**ADMINISTRATIVE APPLICATION CHECKLIST**

**Applicant:** Mesquite SWD, Inc. **OGRID Number:** 161968  
**Well Name:** Scott B SWD #1 **API:** 30-015-44061  
**Pool:** SWD:Devonian - Silurian **Pool Code:** 97869

SWD-1642-A

Re: Order No. SWD-1642  
API #30-015-44061  
Scott B SWD #1

**Well Bore Diagram**

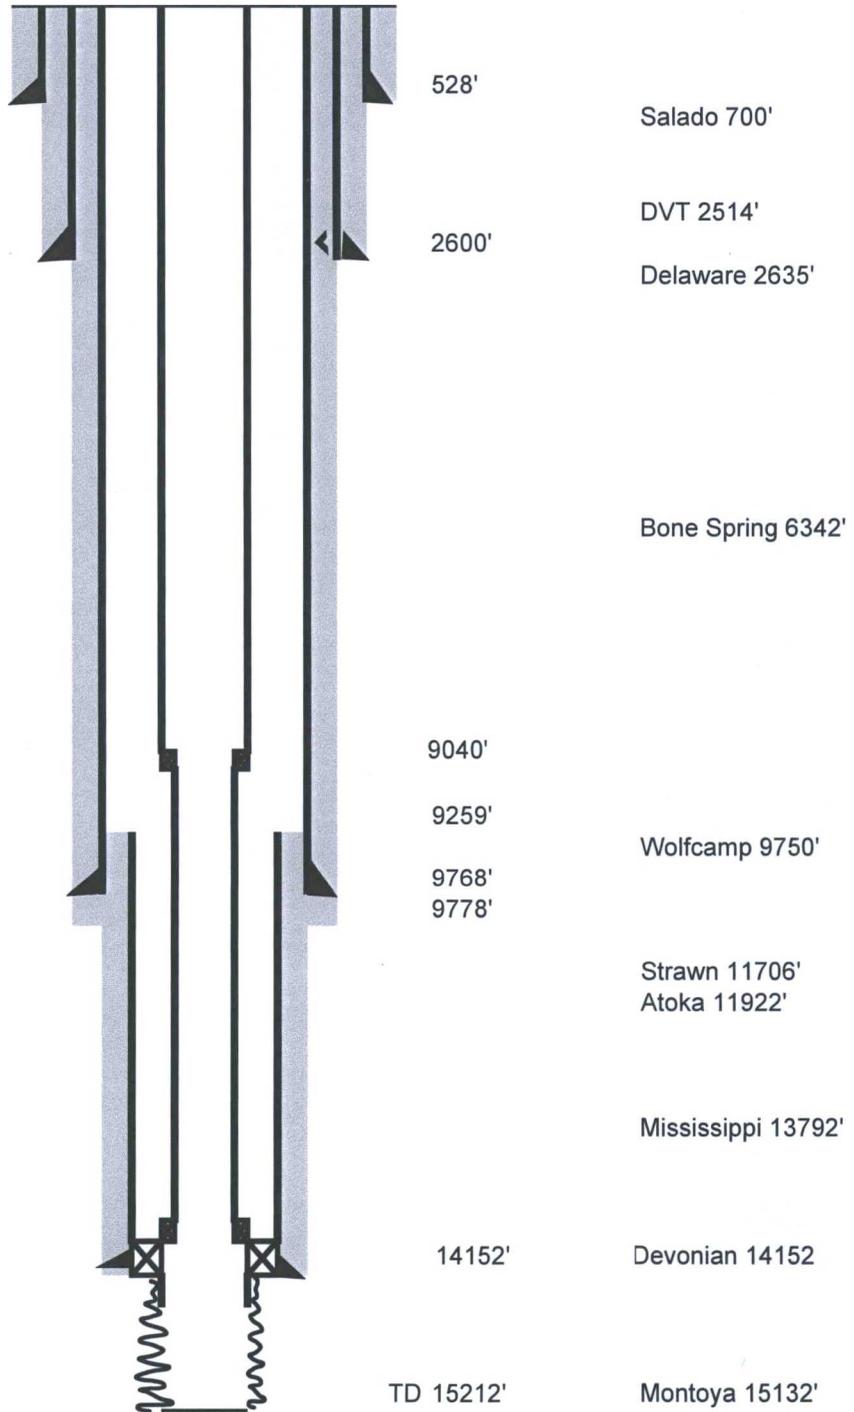
Mesquite SWD, Inc. seeks to amend SWD-1642 which authorizes produced water disposal in the Devonian and Silurian formations through open hole interval 15000 to 16200 feet. We request that this Order be amended to include the Montoya formation in the injection interval with the injection interval being 14152' – 15212'. Attached is a letter from Kay Havenor stating that the Montoya formation will not accept nor yield fluid.

Mesquite SWD, Inc. also requests that SWD-1642 be amended to allow a tapered tubing string, with 5 1/2" tubing inside the surface and intermediate casings and 4 1/2" tubing inside the liner.

**WELL LOCATION AND ACREAGE DEDICATION PLAT**

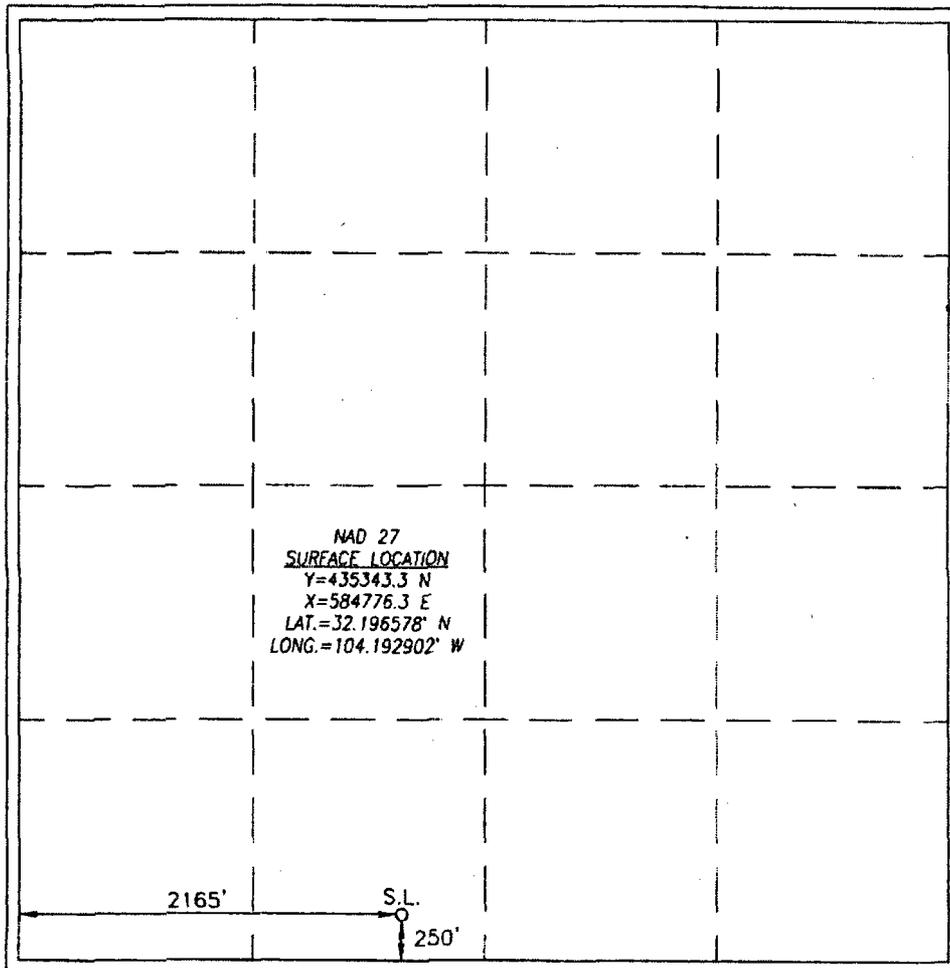
The surface location has changed from the approved permit to the actual location. Proposed surface location 250 FSL and 2166 FWL. Actual location 274 FSL and 2165 FWL, or signed agreement with the surface owner of the changed surface location

Is the surface owner aware of the change? Do you have surface agreement?

I will require a signed statement from Kay Havenor that the ½ mile AOR has not changed.

The Mesquite SWD, Inc Scott B SWD-1642 authorized a location of 250' FSL and 2166' FWL of Section 23, T24S-R28E Eddy Co. NM. Due of field conditions, with the surface owners knowledge and consent, the well was positioned 274' FSL and 2165' FWL.

This modification does not affect the original AOR.

Please be advised that we, Scott and Valerie Branson, agree with the square footage related to the Scott B SWD well site.
